The 9171057 reset switch became obsolete.

A new switch became available, the 9291038, however it has other dimensions.

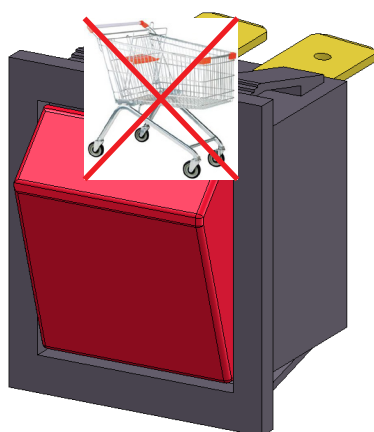
The current mounting hole needs to become a little higher (1,8 mm)
